STAFF RECOMMENDATION

1403 Sharpe Avenue

June 19, 2019

Application: New Construction—Outbuilding/Detached Accessory Dwelling Unit;
Setback Determination

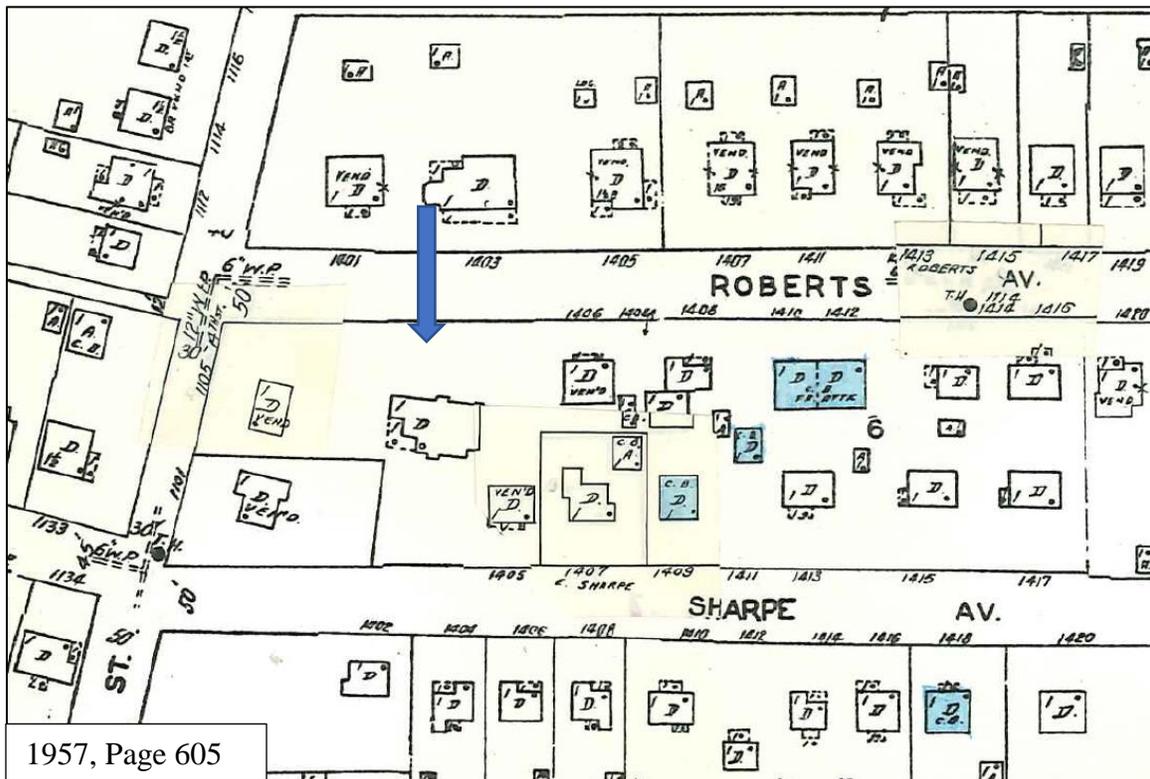
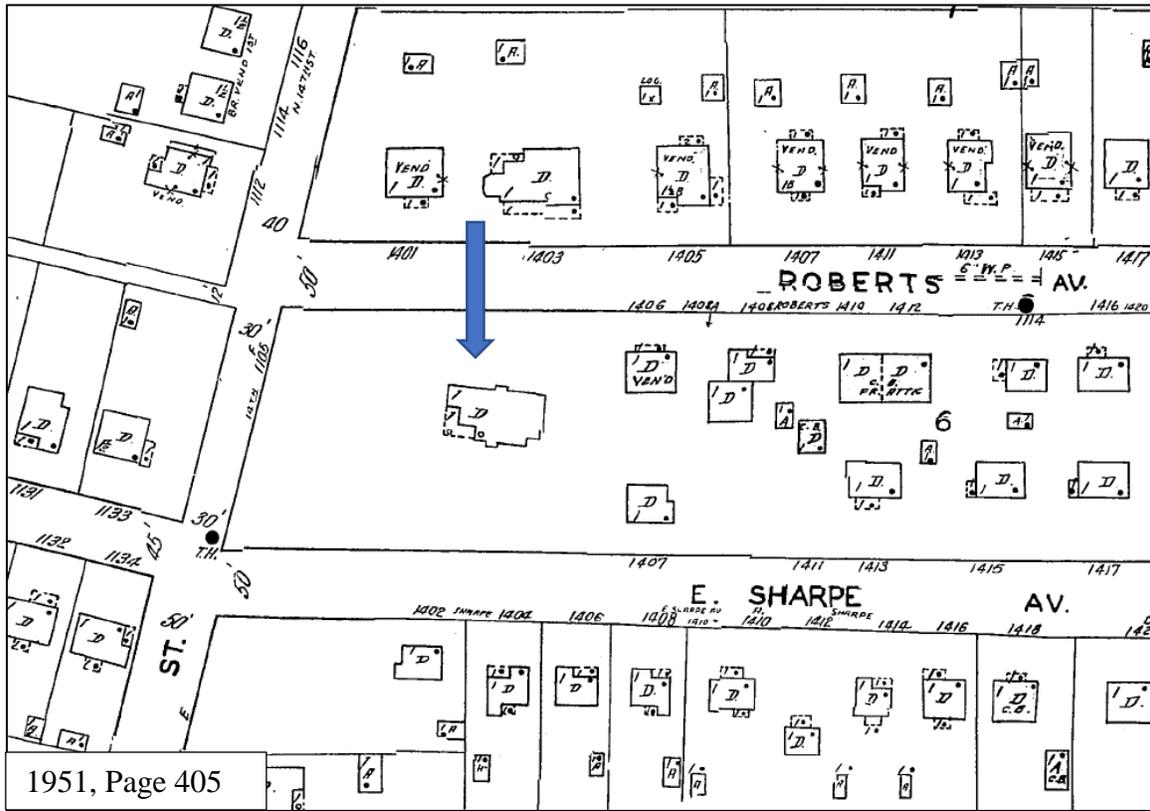
The proposed outbuilding will be located ten feet (10') from the house with a ten foot (10') setback from Roberts Avenue. The Commission generally requires that the distance between a house and an outbuilding is twenty feet (20'). Additionally, the bulk zoning regulations require an outbuilding with garage doors facing a street to have a street setback of twenty feet (20'). Staff finds that in this instance, however, the shorter separation and a lesser rear setback are appropriate because the front yard of the house was subdivided off, which changed the orientation of the house resulting in a shallow de facto rear yard on a lot double-fronted with no alley.

Recommendation: Staff recommends approval of the proposed detached accessory dwelling unit outbuilding with a setback determination with the following conditions:

1. A restrictive covenant for the Detached Accessory Dwelling Unit shall be filed with the Register of Deeds before a building permit is issued, and
2. The window and door selections shall be approved by MHZC staff prior to construction.

1 SITE PLAN

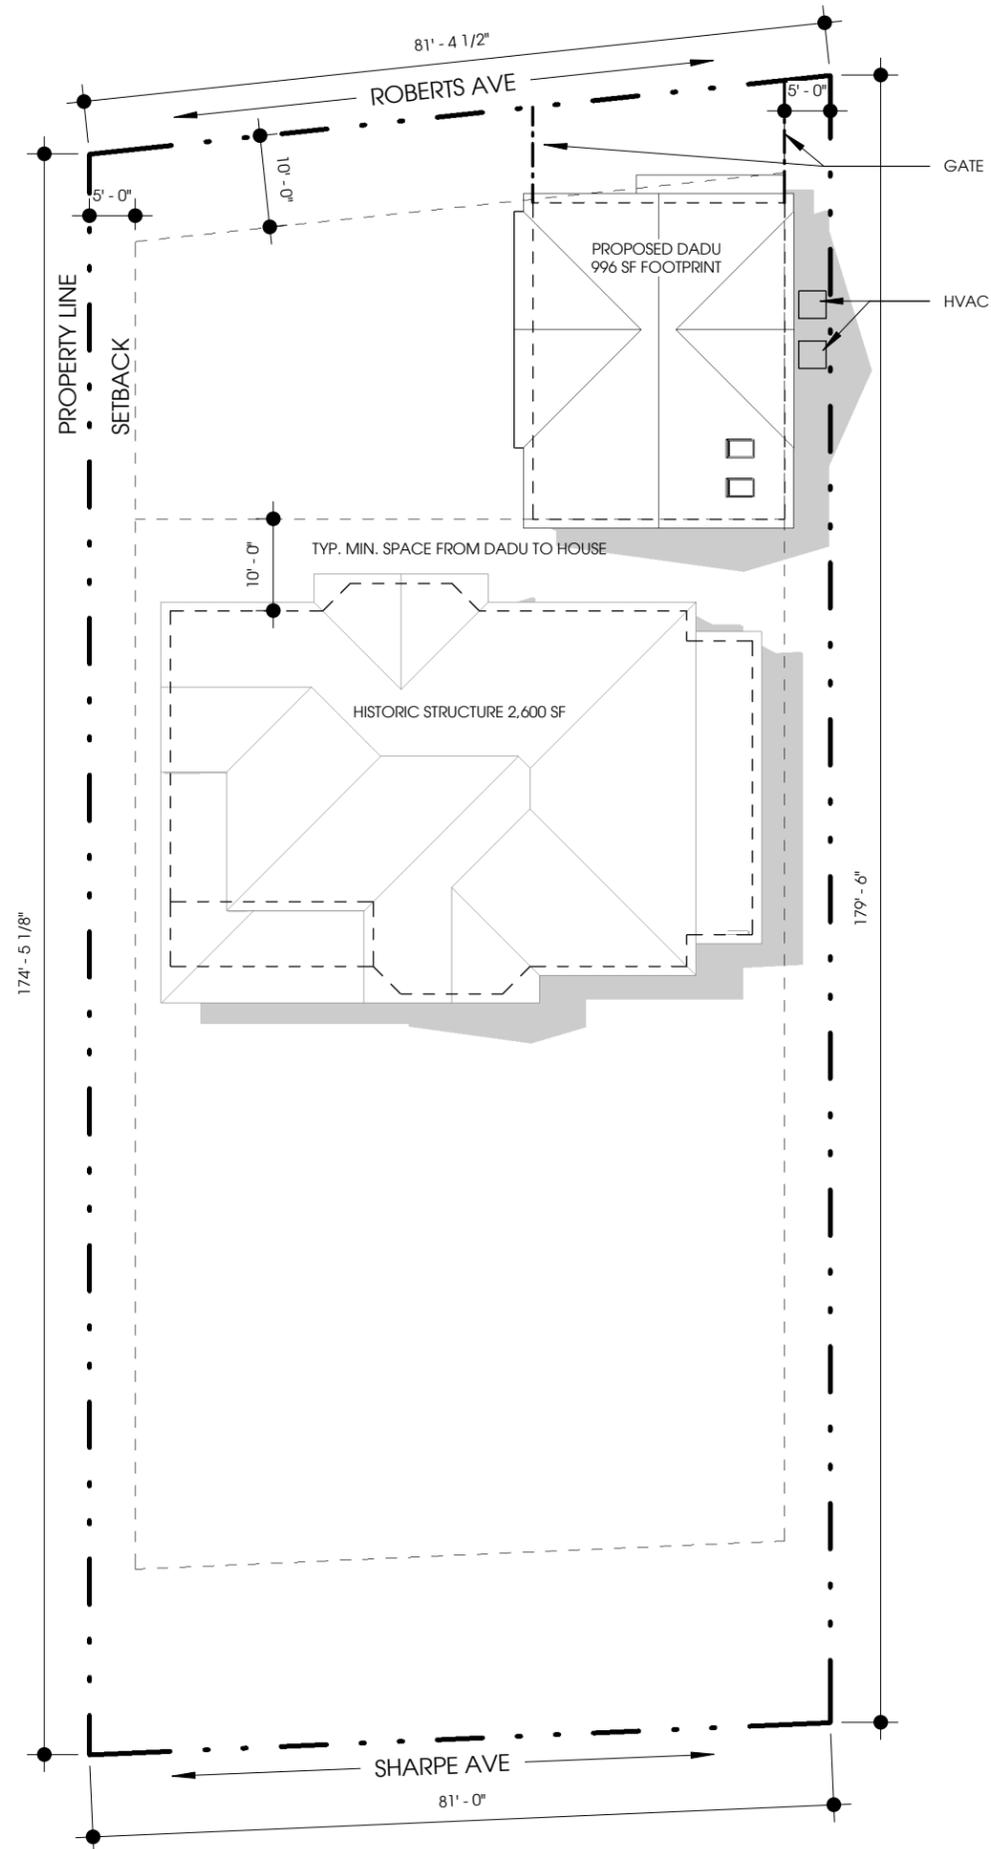
MINIMUM	PROPOSED
Building located towards rear of lot	-	Yes
Space between principal building and garage	20'	10'
Rear setback	20'	10'
Left side setback	5'	48'
Right side setback	5'	5'
How is the building accessed?	-	From Roberts Avenue
Two different doors rather than one large door (if street facing)?	-	Yes

ELEVATIONS

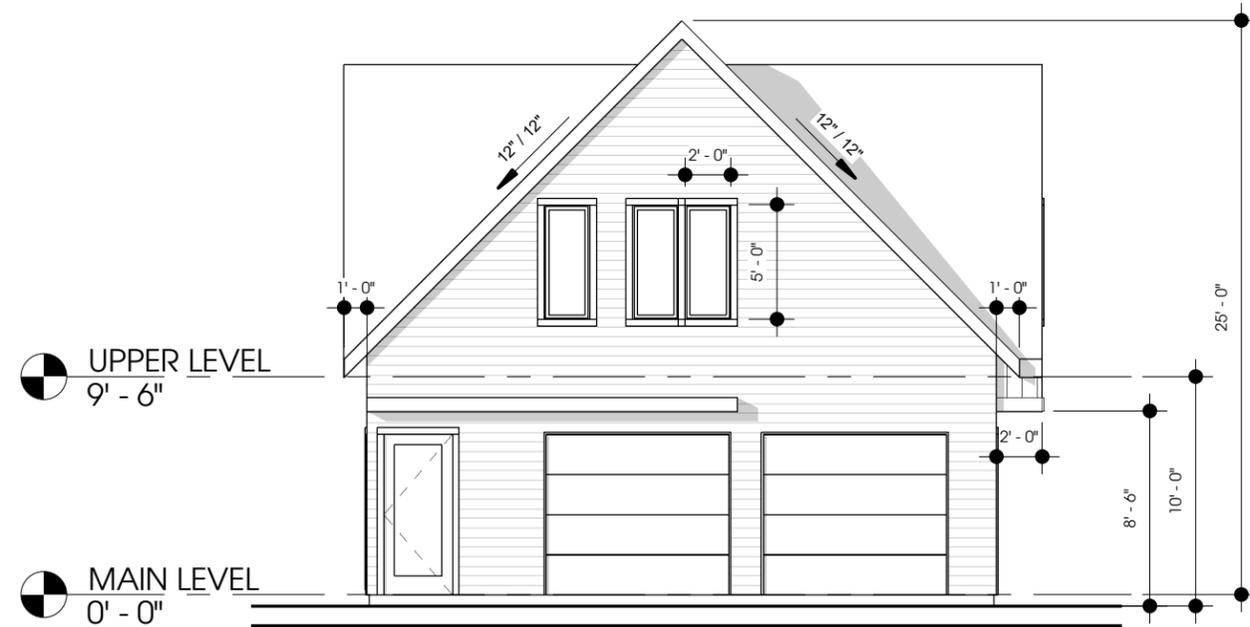
The proposed roof form has a cross-gabled form with a 12/12 pitch on all slopes. This roof form is compatible with the hip and gable roofs on the historic house. Staff finds that the application will meet Section II.B.2.h.1 for roof shape and Section 17.16.030.G.8 for design standards of the DADU Ordinance.

Proposed	Color/Texture	Appropriate or Meets Guidelines?	Needs Final Approval?
Foundation	Concrete Slab	Typical	Yes	
Cladding	Cement-fiber Clapboard	5" Exposure, Smooth	Yes	
Roofing	Asphalt Shingle	Match Existing	Yes	
Trim	Cement-fiber	Smooth	Yes	
Windows	Casement	Wood, Aluminum, or Fiberglass		Yes
Doors	Full-glass	Wood, Aluminum, or Fiberglass		Yes
Garage door	Overhead Panel Door	Not Indicated		Yes

The known materials are appropriate. As a condition of approval, staff recommends the requirement window and door selections be approved prior to construction to be certain that they meet Section II.B.1.d. of the design guidelines.
